*****ERRATA SHEET*****

THE FOLLOWING CHANGES ARE TO BE MADE TO THE PAGES INDICATED IN THE ASSEMBLY MANUAL. BE SURE TO READ THESE OVER CAREFULLY.

8800 GROUNDING MODIFICATION

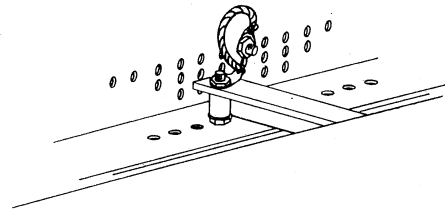
The first connection is to be made between the display/control board and the chassis.

- () Cut a length of the 1/8 inch braid approximately 3 inches and solder a solder lug in place on each end.
- () Referring to the drawing below, attach the braid between the 7805 mounting screw on the back side of the display/control board and the chassis as shown.

NOTE: At any point where a connection is made to the chassis, first rub the area around the connection point with sandpaper or some other abrasive to remove the anodizing.

This connection should be insulated using heat-shrink or some other such tubing.

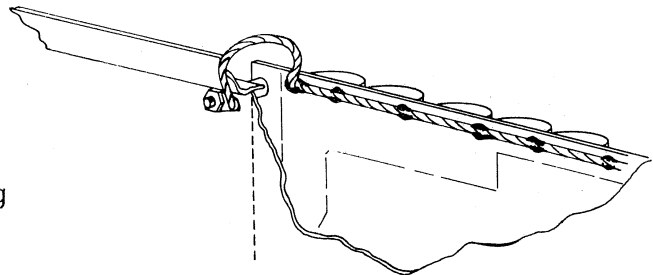
- () Prepare another length of 1/8 inch braid in exactly the same manner as the first piece.
- () Connect this braid between the card rail towards the back of the unit on the side opposite the transformers and the chassis as shown in the drawing below.

- () The 1/4 inch braid is to be soldered directly to the PC land on the bottom (non silk-screened) side of the power supply board. Solder this braid in place along its entire length between the negative side of C1 and the positive side of C14. (see drawing below)
- () Prepare a 4 inch length of 1/8 inch braid by attaching a solder lug to one end.
- () Solder the end opposite the lug on the 4 inch length to the end of the 1/4 inch braid beneath capacitor C1 as shown in the drawing below. The end of the 1/8 inch braid with the solder lug will be attached to the bottom side of the cross member with the same screw which mounts the closest corner of the power supply board.

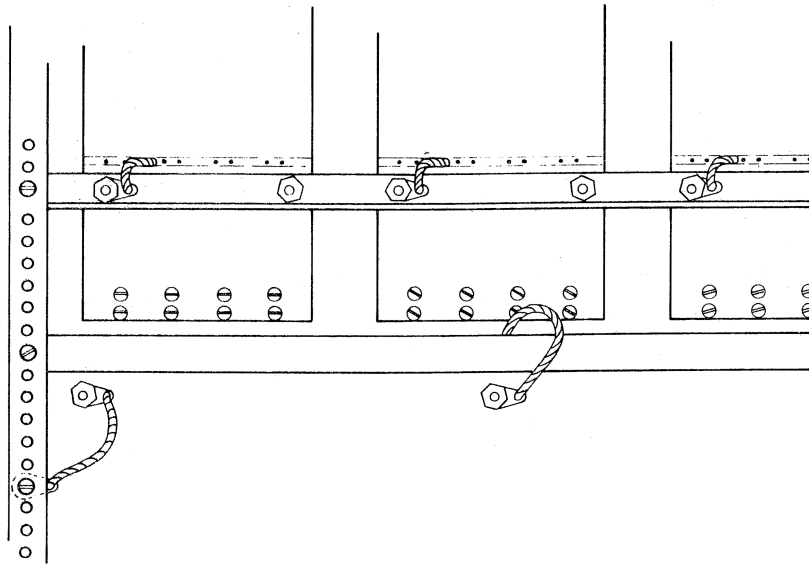
- () Prepare another 3 inch length of 1/8 inch braid by attaching solder lugs to each end.
- () Connect this length of braid between the cross member on the side opposite the transformers and the chassis as shown in the drawing below.

NOTE: The drawing below also shows the 4 inch length of braid from the power supply board properly attached to the cross member as previously instructed.
